PRELIMINARY SHORT SUBDIVISION

STAFF REPORT & DECISION SUB23-003

Project No: SUB23-003

Description: A request to subdivide a 21,916 square foot lot into two new lots. Lot 1 would be approximately 11,329 square feet and Lot 2 would be approximately 10,588 square feet. The existing single-family residence on proposed Lot 1 would be demolished. Access to both lots would be from 78th Avenue SE via a shared access and utility easement.

JOB: 35887
 DATE: 12/21/2023
 SCALE: 1" = 20'
 SHEET: 6 OF 10
 DRAWN BY: BPM & KRS
 CHECKED BY: KAP

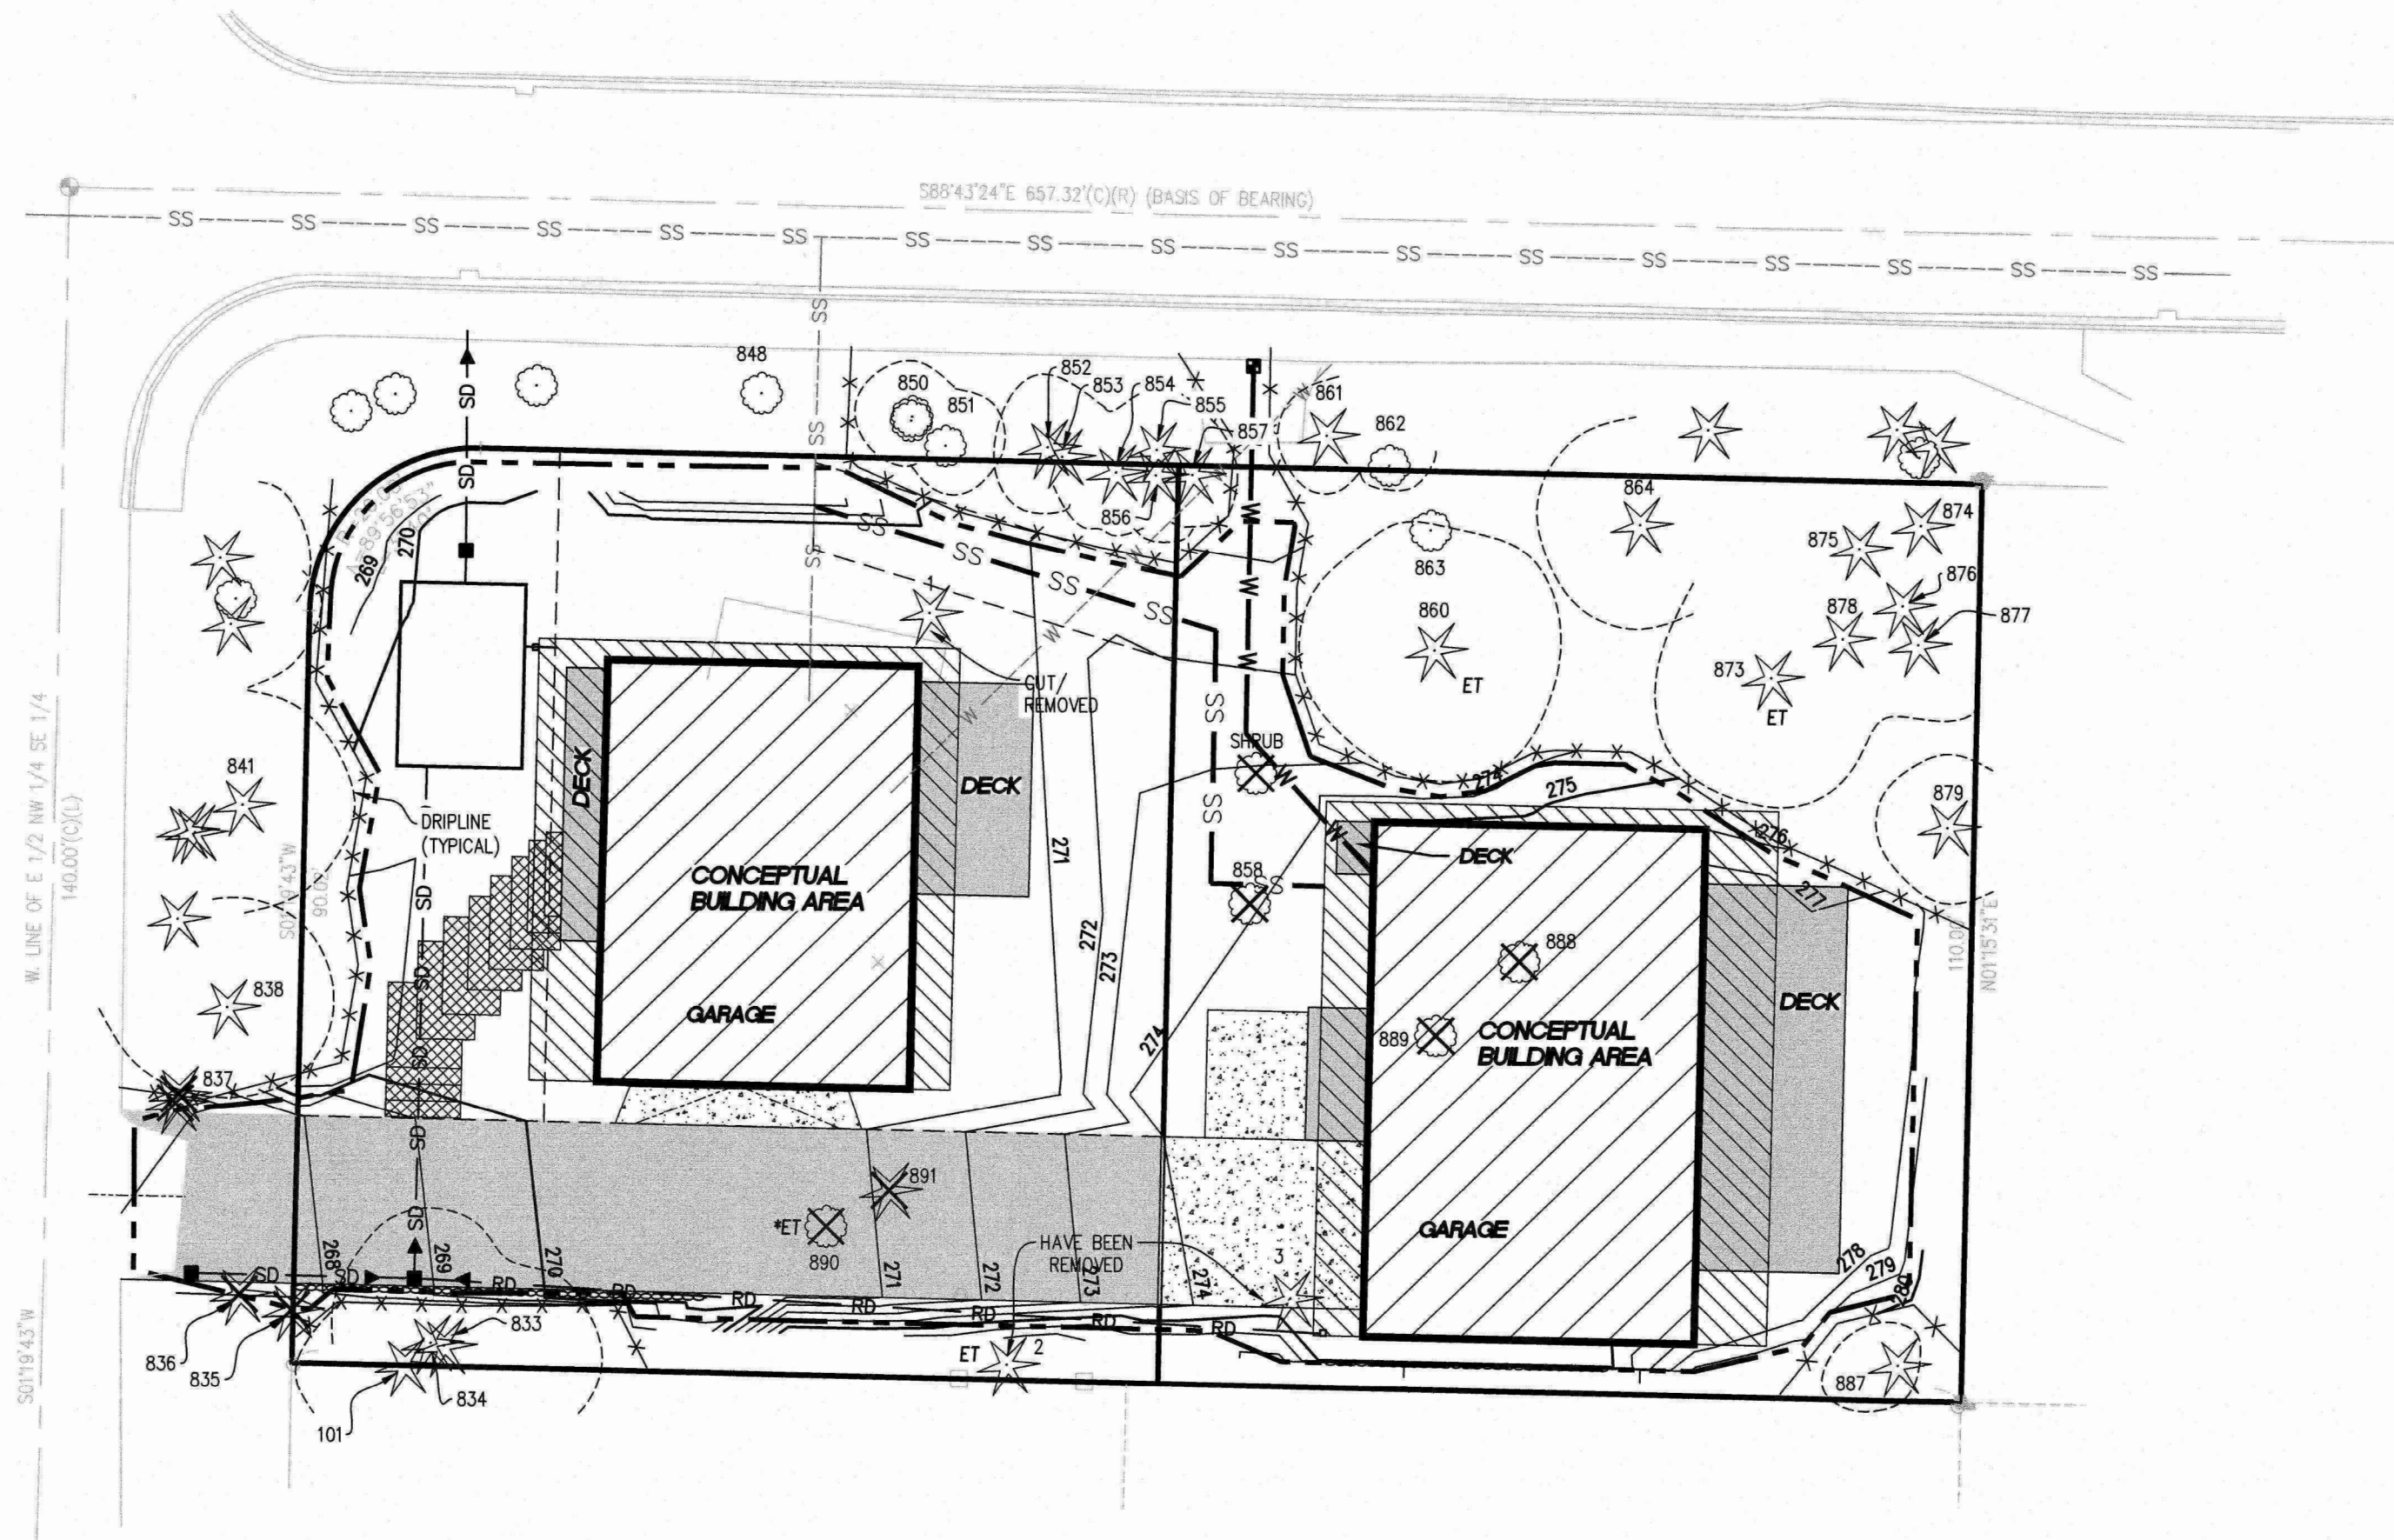
Staff Finding: Building pads, with no cross section less than 20-feet in width, are shown on **sheet 6 of 10** of the proposed development plan set (**Exhibit 5**). The proposed building pad locations minimize the disturbance of the existing, natural topography.

- a. Additionally, MICC 19.09.090(A)(3) requires no cross section of the building pad is less than 20 feet wide. The Building Pad locations shown on Sheet 6 and 10 contain several cross sections that are less than 20 feet wide.

JOB: 35887
DATE: 12/21/2023
SCALE: N/A
SHEET: 8 OF 10
DRAWN BY: BPM & KRS
CHECKED BY: KAP

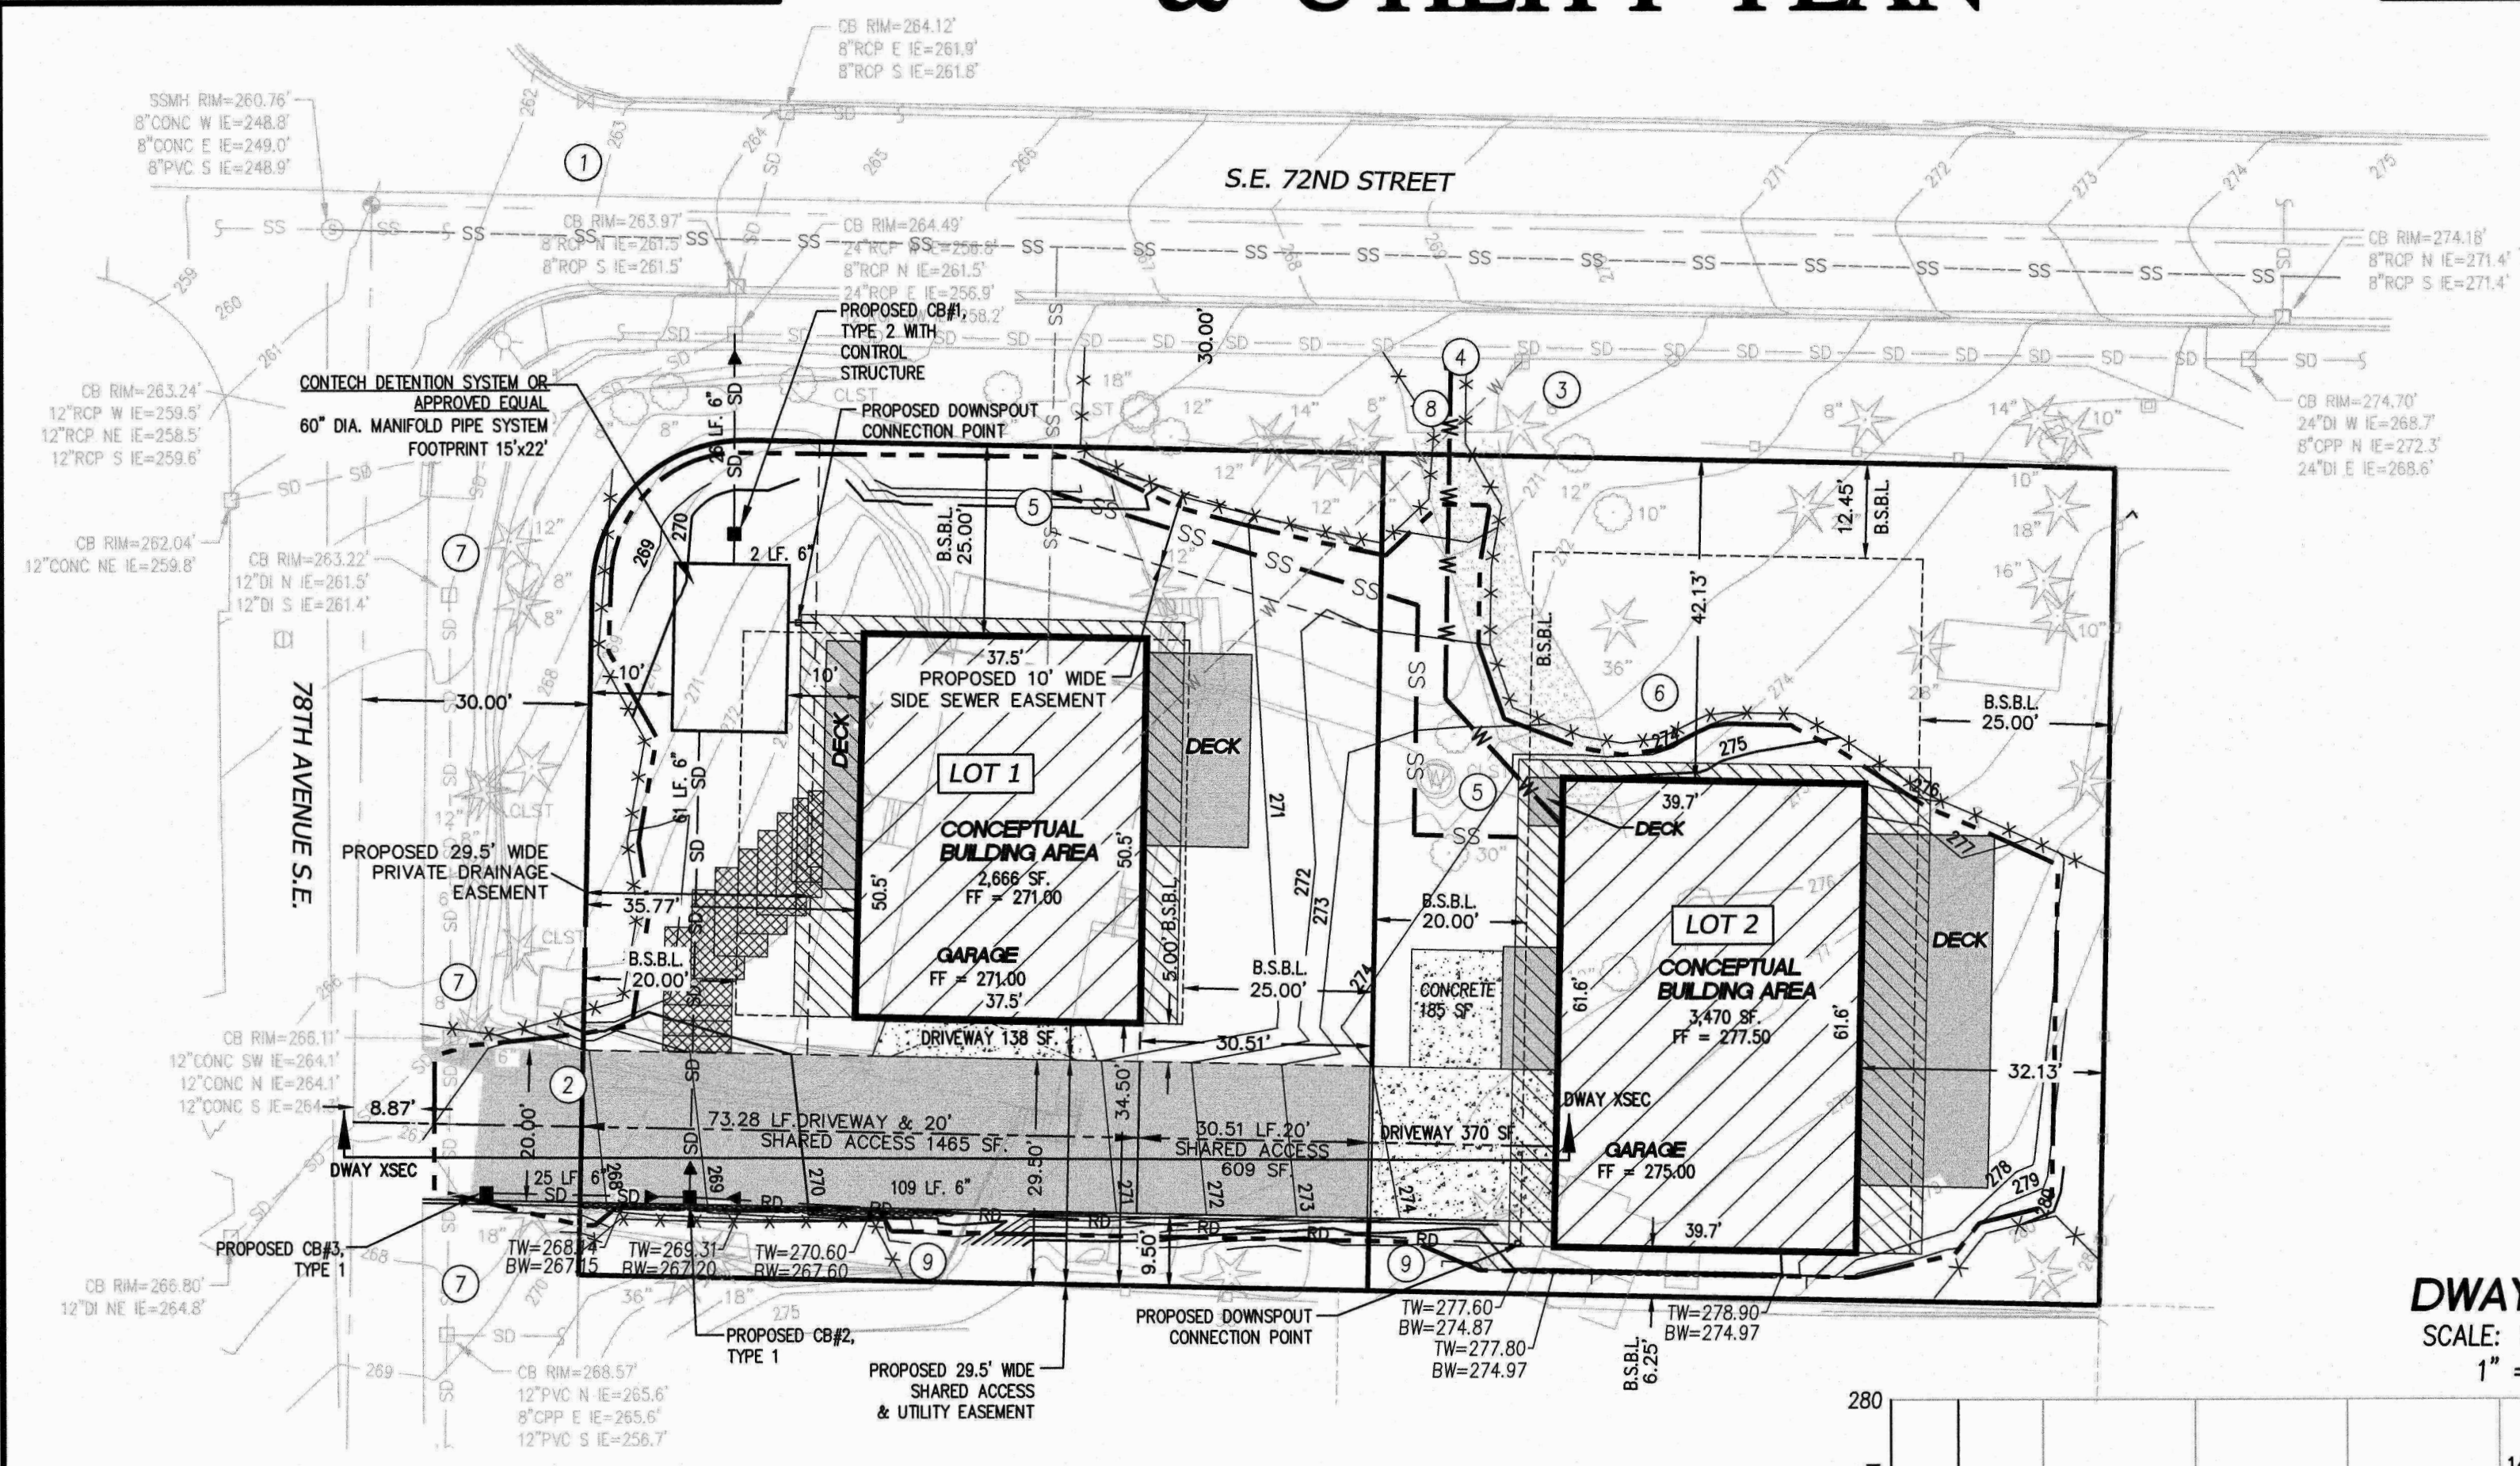
4. Update tree inventory worksheet to exclude trees 880-886 since it is a nonregulated hedge.
5. The clearing limits shown on sheet 7 are within tree 860's tree protection zone. Move the clearing limits outside the tree protection zone.

5. The clearing limits shown on sheet 7 are within tree 860's tree protection zone. Move the clearing limits outside the tree protection zone.
[Response: clearing limits have been adjusted to avoid tree protection zone.](#)
